New Hampshire Yankee

NYN-89134
October 31, 1989

Subject: Request for Additional Information

Schematic Diagrams of Startup Feedwater Pump

START-UP FEED WTR PP I-P-13
ALTERNATE FEED
CLOSE SCHEMATIC

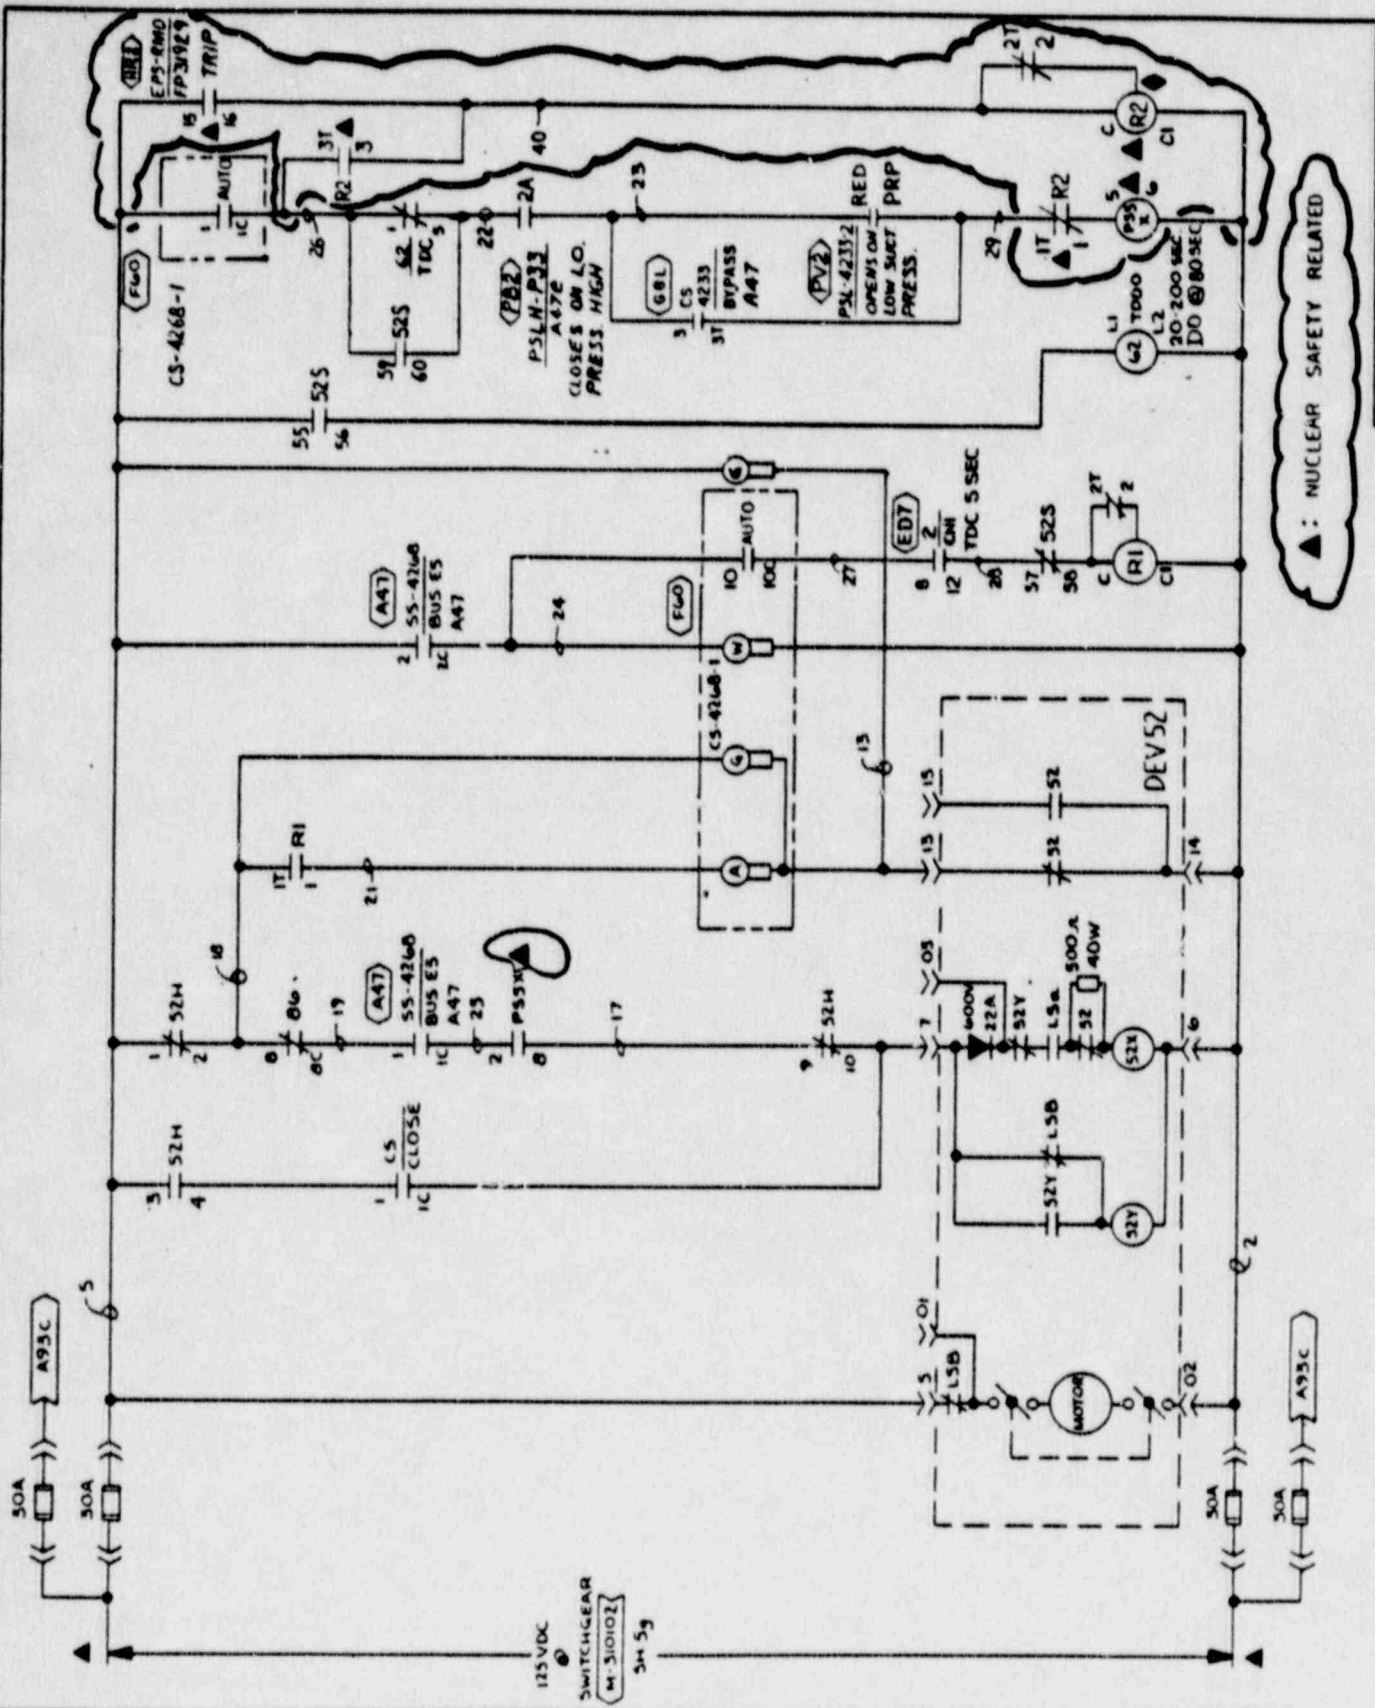
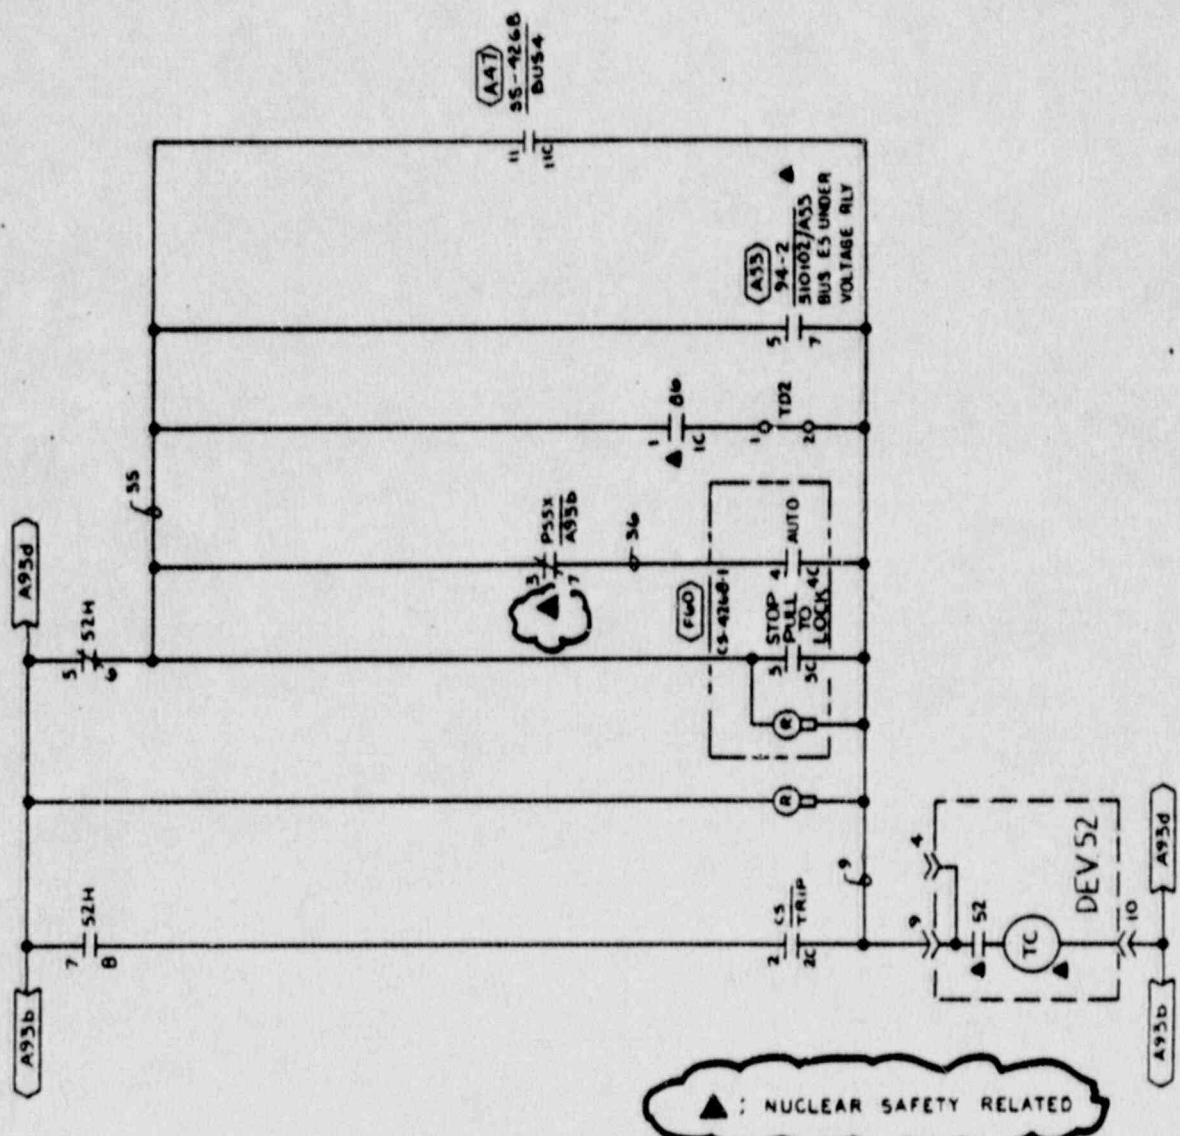
To prevent this unlikely event from occurring, a control circuit enhancement was made as indicated on the attached schematic diagrams. If the SUFF is operating on Bus E5 and a loss of offsite power occurs then the following typical operator action would be taken in accordance with applicable procedures:

- The pump trips on Bus E5 undervoltage.
- The pump is prevented from restarting until the diesel generator has completed sequencing and the operator has depressed the Remote Manual Override (RMO) reset pushbutton and the operator has placed the pump control switch in stop/pull to lock and the operator then returns the pump control switch to auto.
